## SUBDIVISION REVIEW SHEET

**CASE NO.:** C8-2020-0021.0A

**SUBDIVISION NAME:** Fort Branch Subdivision

CITY OF AUSTIN –DEVELOPMENT SERVICES DEPARTMENT  
SUBDIVISION APPLICATION – MASTER COMMENT REPORT

EXHIBIT B

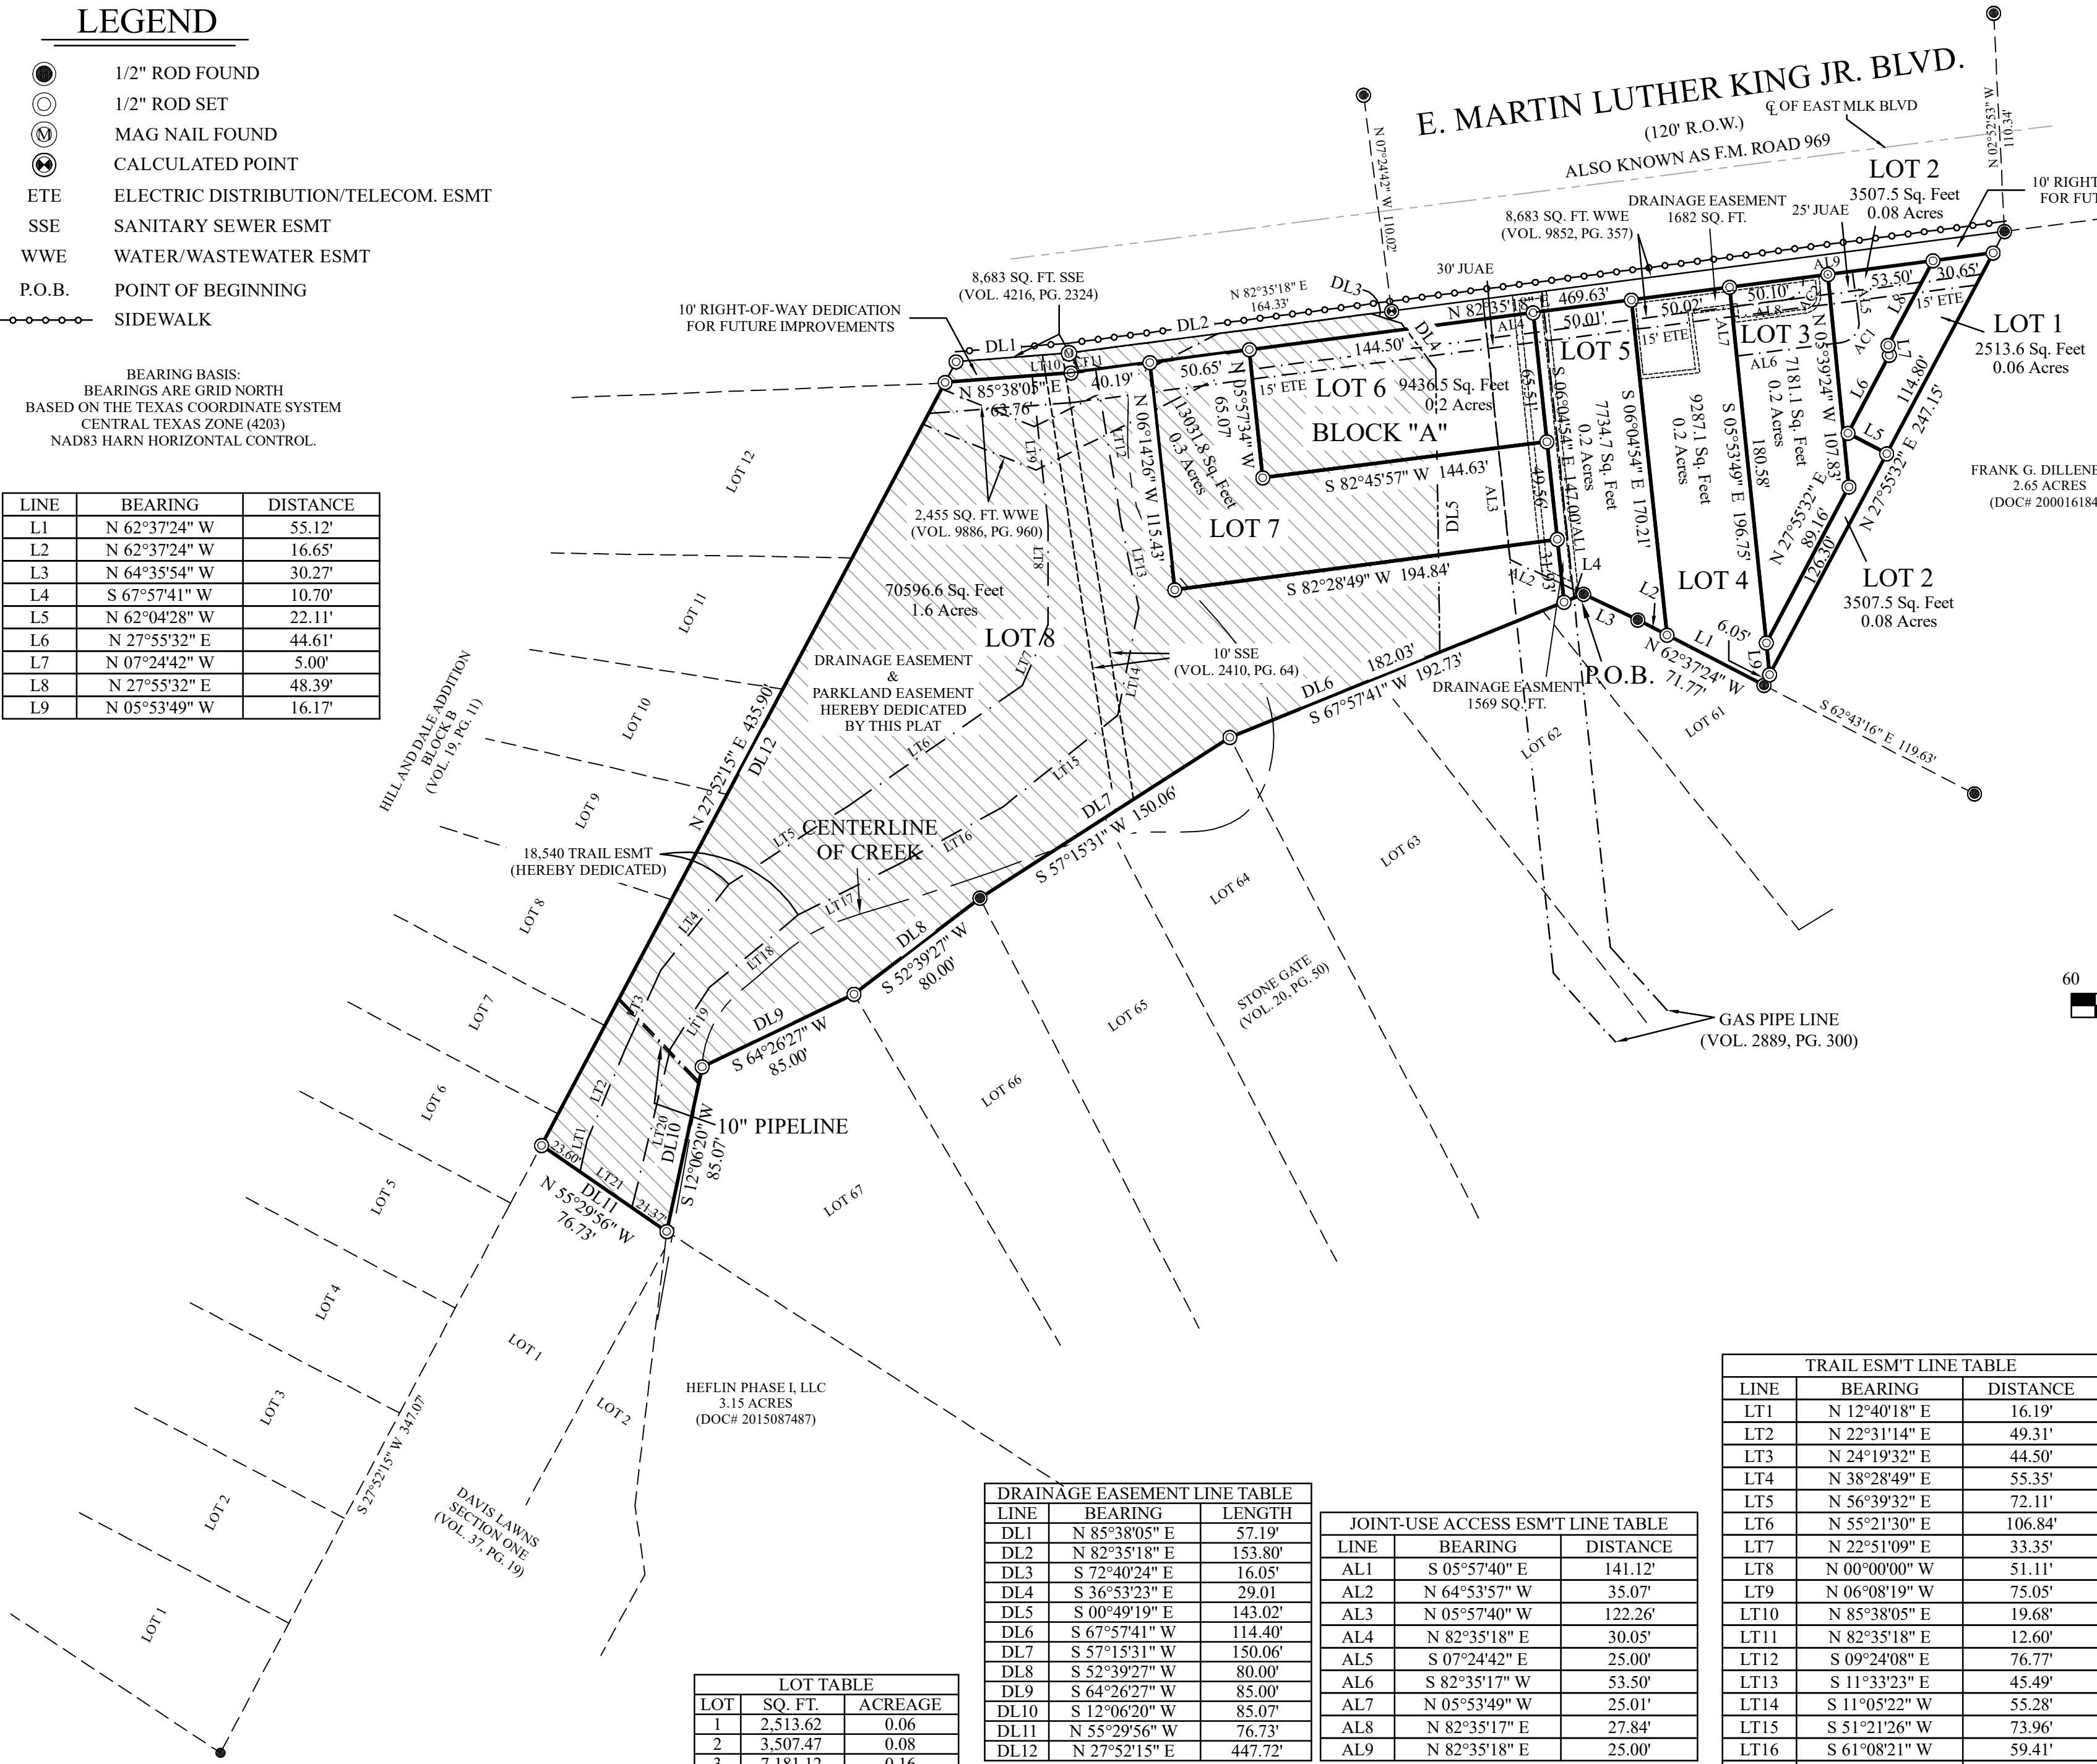
- SR 1. Show all existing easements on the plat, annotate easements accordingly if provided by separate instruments. (L.D.C 25-1-83)  
**Update 1:** Clarify what the hashed area on Lots 6, 7 & 8 is annotating, as shown the hashed area appears to be labeling a Parkland and Drainage Easements. Label easements accordingly and any lots that will be dedicated for Parkland.  
Clearly annotate the Joint Use Access Easement on the lots.  
Clarify what the 10 inch pipeline shown on the south portion of Lot 8 is for and label accordingly.

- SR 2. The plat is demonstrating a gas pipeline are, verify if the plat should comply with the Hazardous Pipeline section of the Land Development Code, Sections 25-4-134 and 25-2-516. If the pipeline meets the definition of a Hazardous Pipeline, the lots will need to comply with lot sizes as stated in 25-4-134(D) and other requirements as listed by code. A sign off or acknowledgement that the pipeline is not considered a Hazardous Pipeline will be needed from the Fire Department reviewer to clear this comment.

**Update 1:** The plat is showing a gas pipeline line within the proposed lots, a determined would be needed stating that the pipeline is not a hazardous pipeline for LDC 25-4-134 section of code not to apply to the case. A certified acknowledgement would be needed stating that the pipelines is not considered hazardous pipeline, refer to [LDC 25-4-134](#) for Hazardous Pipeline definition and requirements.

- SR 3. The property is zoned SF-3, minimum lots size for the zoning category is 5,750 square feet. Verify that the lots on the plat meet the zoning criteria. (L.D.C 25-1-83 / [25-2-492](#))

**Update 1:** Proposed Lots 1 through 7 are in Tract 104 as demonstrated in Ordinance 021107-Z-12b which allows Residential Infill Special Use with various residential uses. The proposed lots within the infill special use area can follow [L.D.C 25-2-1534](#) for development standards. Verify that the propose lots meet the criteria listed in L.D.C 25-2-1534, and that the plat meets requirements for the various number of uses the infill list. Note that the development requirements state that Single-Family residential uses are required on land that is adjacent to property zoned SF-3 or more restrictive, small lot uses do not appear to be correct uses for Lots 1 and 2.

- SR 4. Lots should have a minimum width of 50 feet starting at the front building setback line ending 50 feet towards the rear of the lot. Verify that the lots meet the lot width requirement, as shown Lots 1, 2 and 6 do not meet the lot width requirement. L.D.C. [25-1-22\(C\)](#)

**Update 1:** Label the lots that will have small lot use, such as Cottage or Urban Home uses, and provide a note listing the lots that will follow the Residential Infill Special Uses.

- SR 5. Comment Cleared.
- SR 6. Comment Cleared.
- SR 7. Clarify if Lot 2 extends to East M.L.K between Lot 1 and Lot 3. If this is correct show a callout of the area between Lot 1 and Lot 3 showing that Lot 2 is part of the triangular area along the road to show frontage for the lot. Lots not having frontage to an existing roads require a commission approved variance to finalize a plat. L.D.C [25-4-171](#)

**Update 1:** Provide a callout of the area in Lot 2 along lot lines L5, L6 and the east lot line of Lot 3. The callout is needed to demonstrate that the triangular area and the strip of Lot 2 are connected.

- SR 8. Add the lot totals on the Lot Table. (L.D.C 25-1-83)  
**Update 1:** In the Lot Table show the total acreage and square feet totals, as well as listing the area of the right-of-way to be dedicated.

SR 14. Update the owner's dedication statement on Sheet 2 as follows: 25-1-83, TX 212.004(c)

**Update 1:** Update the preamble to list the current owner and match provided deed.

Reference for comment #3

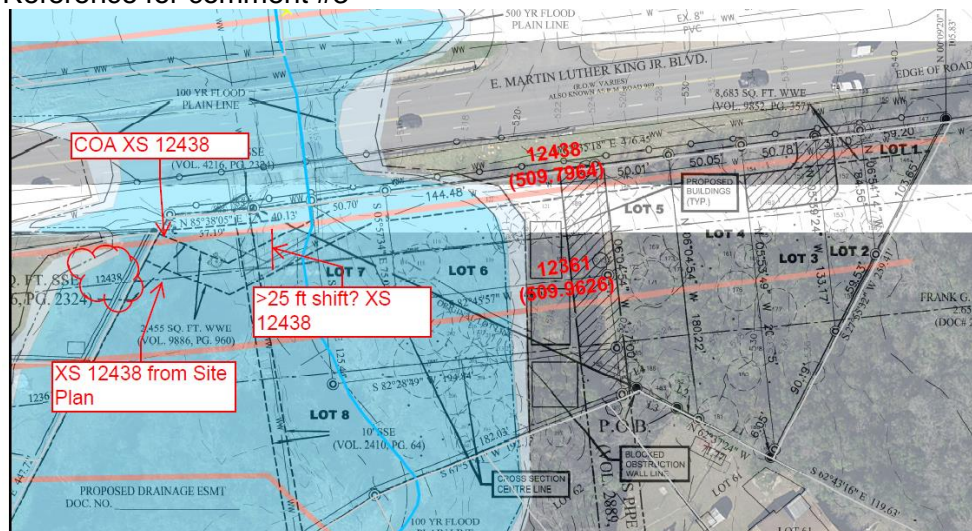
3. If the COA floodplain models were altered for this project, a project assessment is required. Looking at the submittals, it appears that FEMA 500- year floodplain is being used in place of Atlas 14 100-year and the floodplain/drainage easement is proposed to be dedicated accordingly. However, this cannot be confirmed and verified, since there seemed to be a shift in HEC-RAS cross sections in Exhibit 11 (please see the snip at the end of the FP comments below). Please double check the RS of those cross sections and other components of the models and explain the shift. It also helps to verify the delineation quickly if the applicant provides the shape files of HEC-RAS XS, 100-yr and 500-yr FP, and the Georeferenced site plan image used to plot in the plan sheets and exhibits.
